PROPOSED CHANGE NO. 8

SOUTHWEST EXPERIMENTAL FAST OXIDE REACTOR

OCTOBER 16, 1971

DOCKET 50-231

Figure 1. Limits for Poison Slug Worths

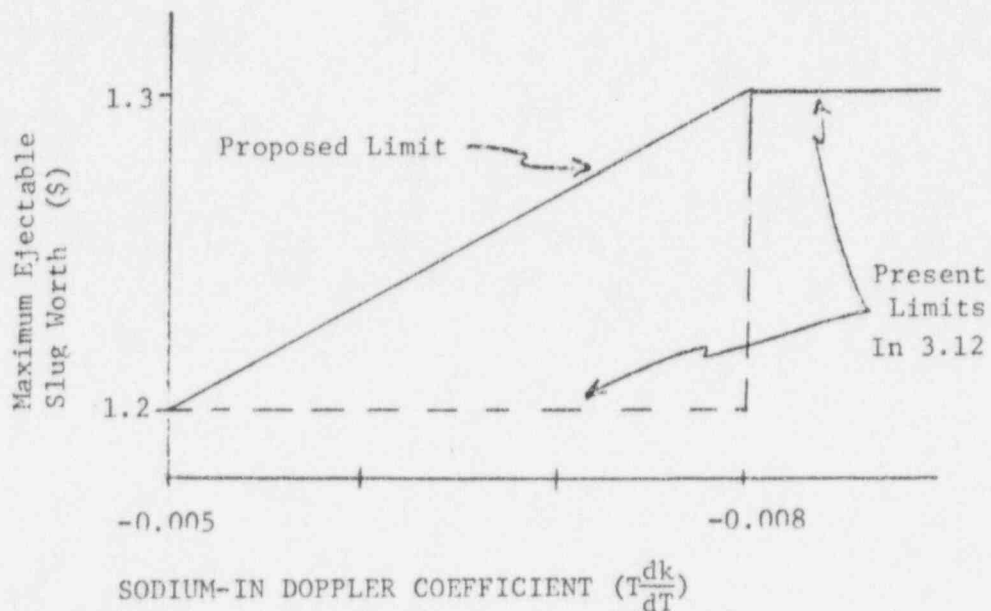
perform the superprompt critical transients with the maximum permissible poison slug worth consistent with safety considerations. Therefore, it is proposed that the present limit of 1.2\$ for any Doppler coefficient with a magnitude of less than 0.008, be changed to permit a linear interpolation between the present values for the limiting slug worth as a function of Doppler coefficient. This would result in a limiting slug worth of 1.26\$ for a Doppler coefficient of -.0069. This method of determining the limit will provide equivalent margins with respect to the design transient for any acceptable value of the Doppler coefficient, as discussed below. The observed values of the dynamic slug worth will be used for comparison to the limits as discussed on page 3 of Ref. (3).

Figure 1 compares the proposed limits for slug worth to the present limits.

FIGURE 2: POWER DURING SUPER-PROMPT CRITICAL TRANSIENTS

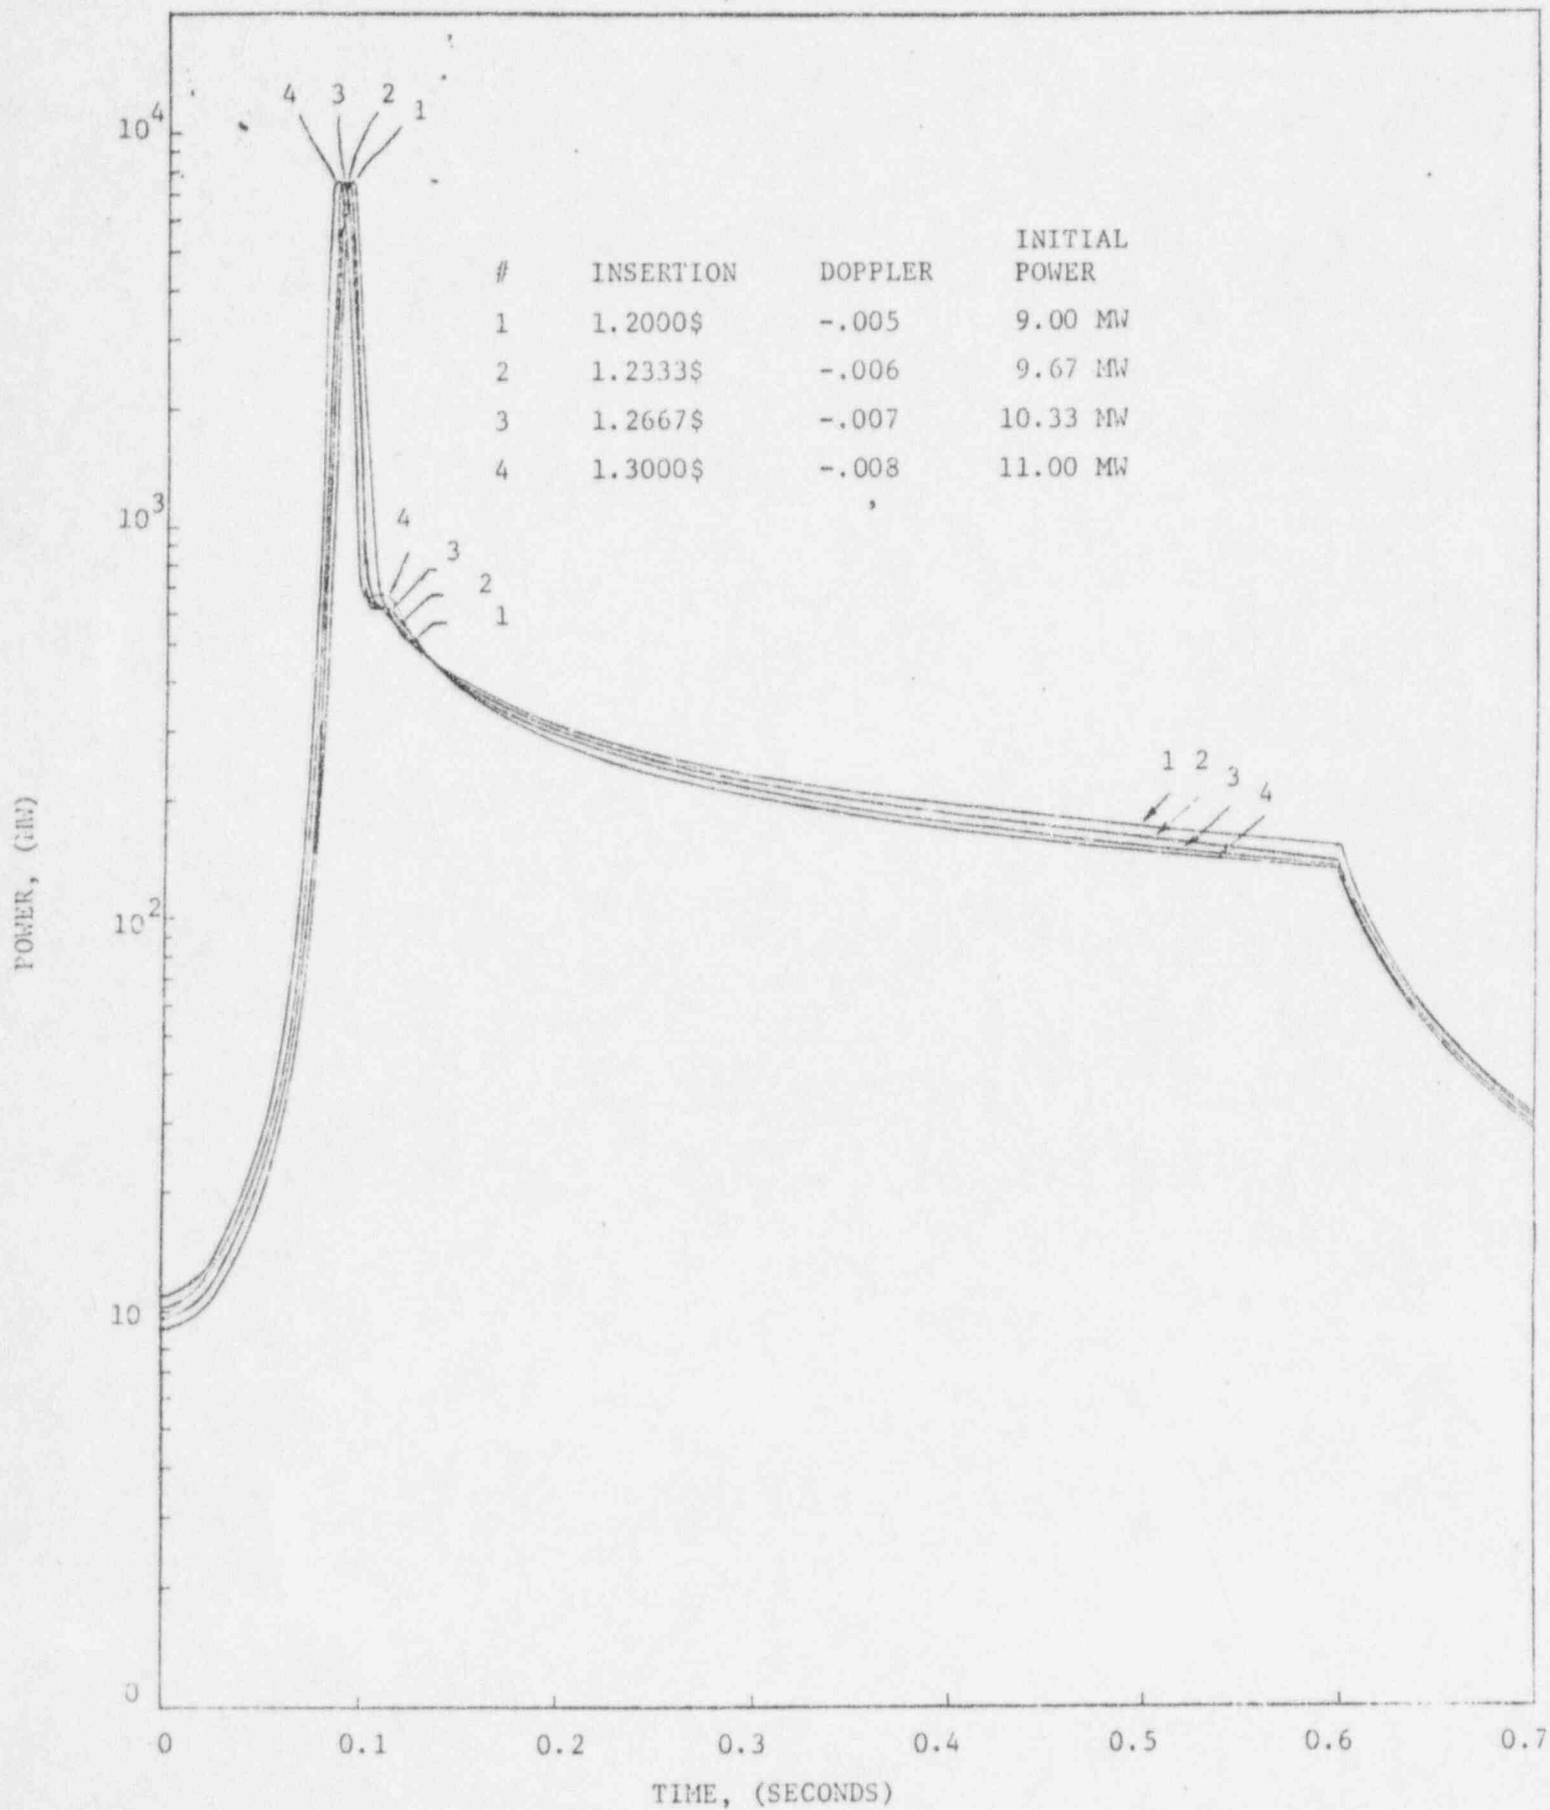
The calculated values of power and increase of the average fuel temperature are given in Figures 2 and 3 for transients with Doppler coefficient values of -0.005, -0.006, -0.007, and -0.008, and with reactivity insertion values corresponding to the proposed limit.

From these figures it can be seen that the proposed limits for intermediate values of the Doppler coefficient provide an envelope for transient tests which is consistent with the present limits for Doppler coefficients of -0.005 and -0.008.

It should be noted that the values obtained from Figures 2 and 3 represent the maximum values since they are based on the maximum initial power level consistent with the core loading limit of .50\$ and on start of reflector movement (scram) at 0.600 seconds. Thus the proposed limits provide margins with respect to the design transient which are equivalent to the margins provided by the present Technical Specifications for Doppler coefficients of -0.005 and -0.008.

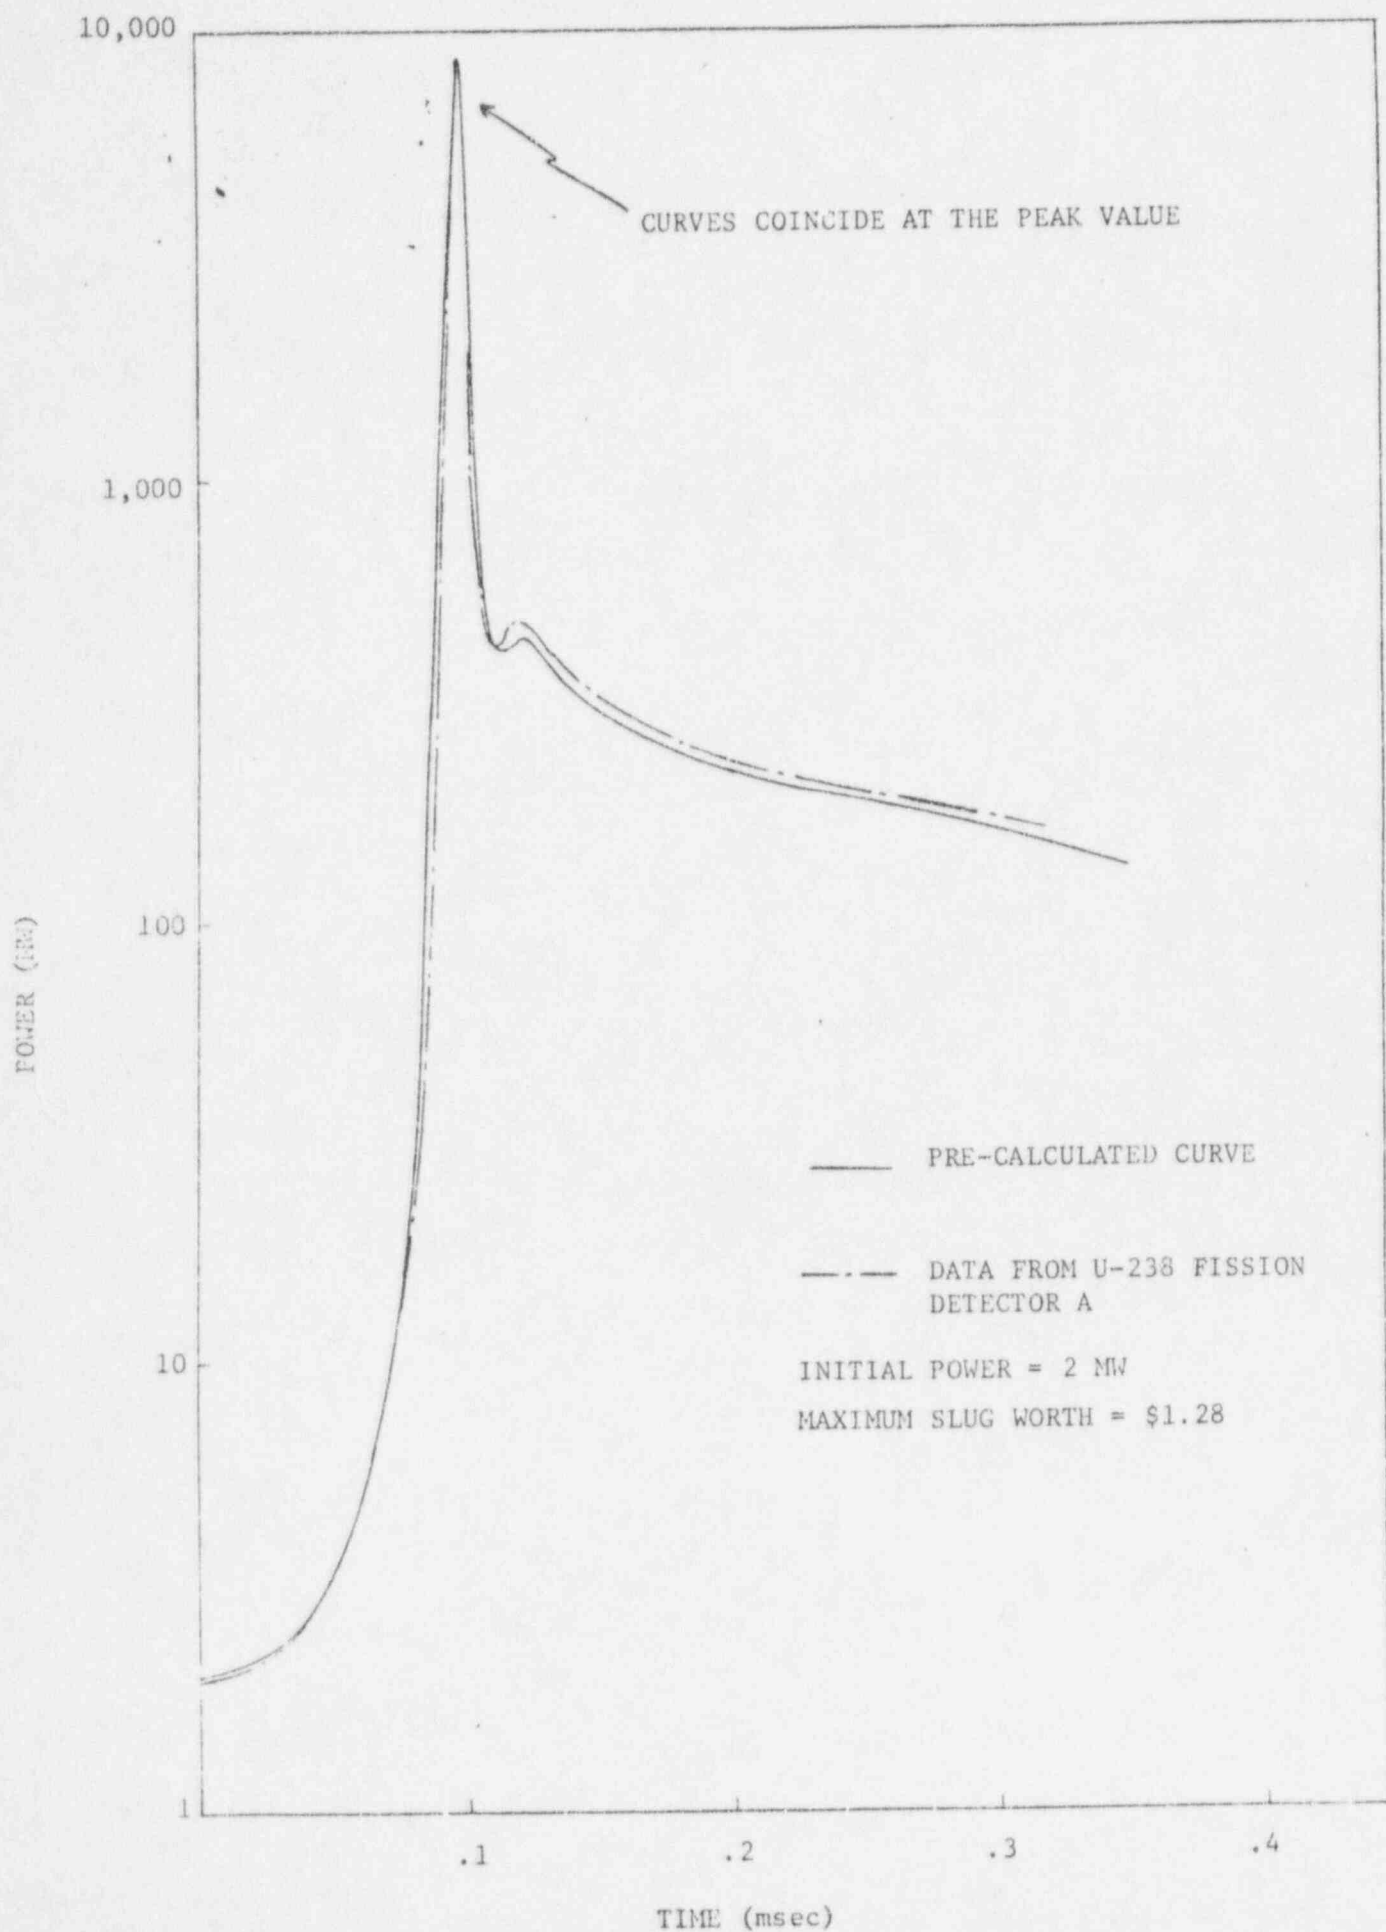
The data for superprompt transient No. 2 are plotted in Figure 4. Non-Doppler feedback coefficients contribute about 12 percent of the total feedback during the transient. This comparison provides assurance that the results of transient tests for Core II can be accurately predicted by use of the available analytical tools and test data.
